Re: Valiano Specific Plan, SCH NO. 2013061042—Public Comments on Draft Environmental Impact Report

The following comments are submitted on behalf of the Elfin Forest Harmony Grove Town Council regarding the Draft Environmental Impact Report (DEIR) for the Valiano Specific Plan Project.

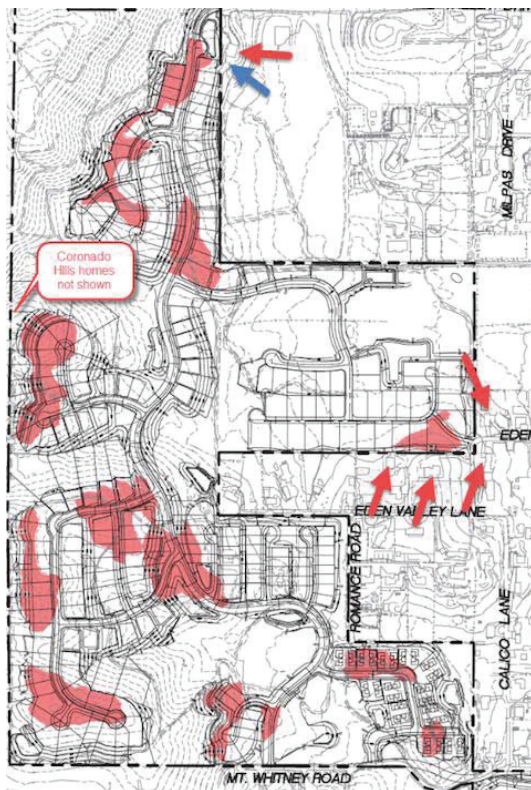
The diagram included in the DEIR does not show the homes on Coronado Hills in San Marcos - yet by referencing other maps it appears blasting is proposed right below existing homes, conveniently located in another jurisdiction which does not get to decide on the project approval outcome. See, Exhibit A for further reference to Coronado Hills homes.

K-151 Figure 2 in the AAR shows the areas surrounding the Project, similar to the map within the Exhibit A of the commenter's letter. In Section 2.6.1.4 of the EIR, existing noise-sensitive land uses in the Project vicinity are described, which include areas north, east, and west of the Project site. Mitigation applies to any construction activities within the setback distances described in the measures (see Response K-150a). No comments were received from the City of San Marcos regarding blasting and/or noise issues.
